SUNDRY NOTICES AND REPORTS ON WELLS
Do not use this form for proposals to drill or to re-enter an abandoned well. Use form 3160-3 (APD) for such proposals.

WELL NAME: Benson Deep BDX Com #1 **FIELD:** Nimenim Ridge
LOCATION: 660' FSL & 2,180' FEL of Section 33-18S-30E Eddy Co., NM
GL: 3,404' **ZERO:** 14' **KB:** 3,418'
SPUD DATE: 1/27/79 **COMPLETION DATE:** 5/10/79
COMMENTS: API No.: 30-015-22793

Benson Deep BDX Federal Com 1
Yates Petroleum Company
30-015-22793
18 Oct 2011
Conditions of Approval

WELLBORE SCHEMATICS ATTACHED

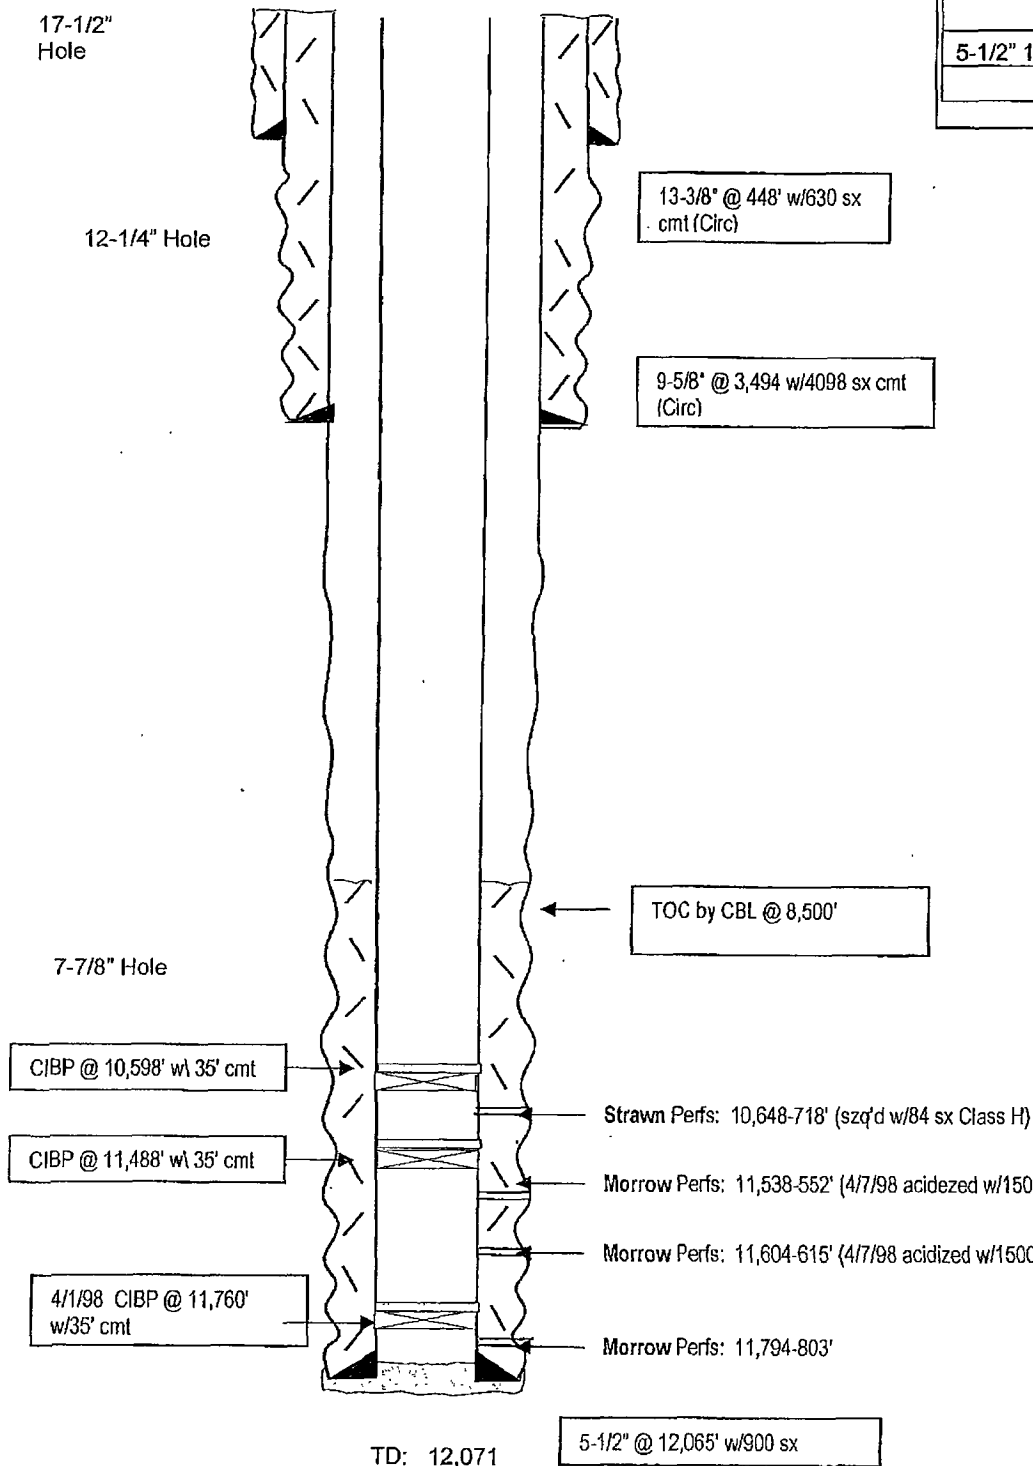
Yates Petroleum Corporation plans to recompleat this well as follows: RU any safety equipment as needed. NU BOP. Pull a CBL and verify TOC. Perforate 4 squeeze perforations 50' above the observed TOC. TIH with packer and set it 250' above the squeeze perforations. Open all valves on the bradenhead and attempt to break circulation behind the 5-1/2" casing. Set a cement retainer 50' above the squeeze perforations. Sting into the retainer. Pump a squeeze job to bring the new TOC up to +/-2600'. WOC and drill out the cement retainer. Perforate Bone Spring 8316'-8370' (55). Stimulate as needed. Swab test and evaluate. If well looks productive put it on pump to test. Set a composite BP at 8261'. Perforate Bone Spring 7410'-7450' (41). Stimulate as needed. Allow the gel to break and the resin to cure. Flow the well back if it will flow. TIH with bit to drill out composite BP and wash sand down to 8600'. TIH with production equipment and turn well over to production.

- c) **BOPE:** The Operator is responsible to provide BOPE of sufficient rating for proper well control. **2000 (2M) BOP or larger** to be used. (2M is based on formation water pressure gradient.) All blowout preventer (BOP) and related equipment (BOPE) shall comply with reasonable well control requirements. A two ram system with a blind ram and a pipe ram designed for the size of the work string shall be adequate. Tapered work strings will require an additional pipe ram. The manifold shall comply with Onshore Oil and Gas Order #2 Attachment I (2M Diagrams of Choke Manifold Equipment). The accumulator system shall have an immediately available power source to close the rams and retain 200 psi above pre-charge. The pre-charge test shall follow requirements in Onshore Order #2.

- d) **Wellbore Integrity:** Test casing as per Onshore Order 2.III.B.1.h
- e) **H2S:** Reported in sections to west, north, northeast. Although Hydrogen Sulfide has not been reported in this section, it is always a potential hazard. It is recommended that monitoring equipment be onsite for potential Hydrogen Sulfide. If Hydrogen Sulfide is encountered, please report measurements and formations to the BLM.

- f) **New TOC:** Operator is responsible to verify new TOC after pumping cement.
- g) **Logging:** A copy of the CBL and any other logs run shall be submitted to the BLM office as well as all other logs run on the borehole 30 days from completion. If available, a digital copy of the logs is to be submitted in addition to the paper copies.
